EN 1992-1-1:2004/AC

Eurocode 2: Design of concrete structures - Part 1-1: General rules and rules for buildings

Ref. No.:EN 1992-1-1:2004/AC:2010 D/E/F

Modifications due to EN 1992-1-1:2004/AC:2008 (as modified by EN 1992-1-1:2004/AC:2010)

a2) Braced

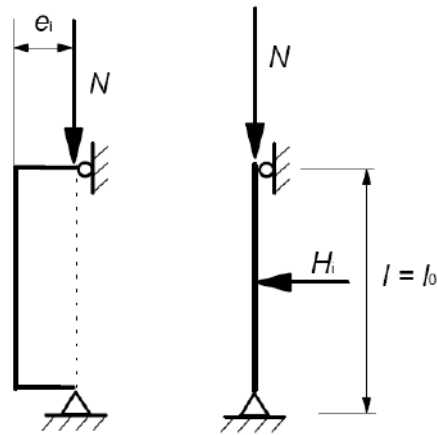
Replace Figure 5.1 a2) with the following one:

Figure 6.18 — Slab with enlarged column head where $l_H > 2(d + h_H)$".

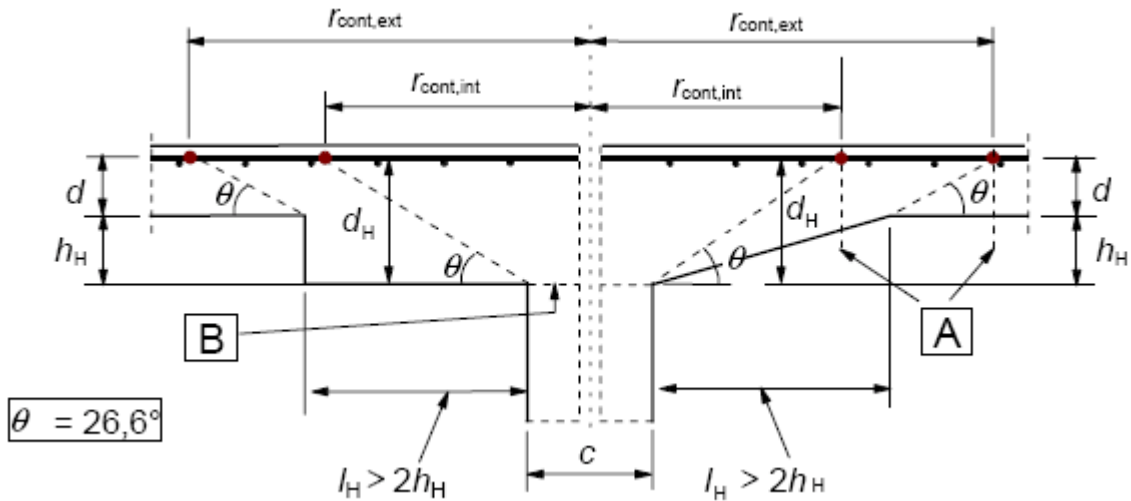
Paragraph (11), replace Figure 6.18 with the following one:

a) Basic tension anchorage length, $l_{b,rqd}$, for any shape measured along the centerline".

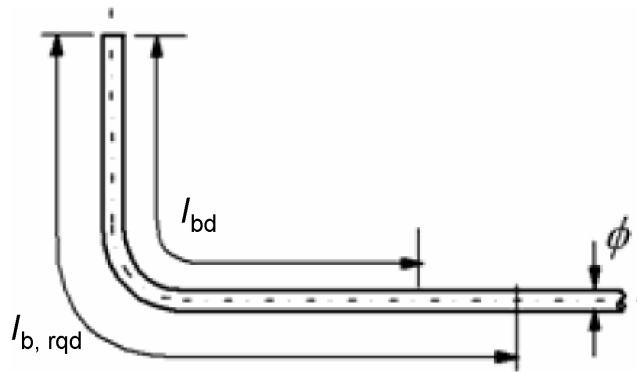
Paragraph (2), replace Figure 8.1 a) with the following one:

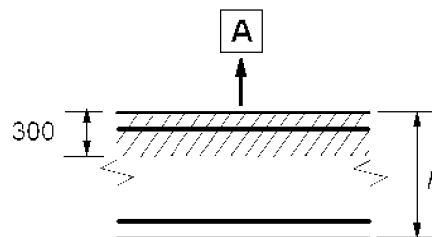
*Paragraph (2), replace Figure (8.2) with the following one:*
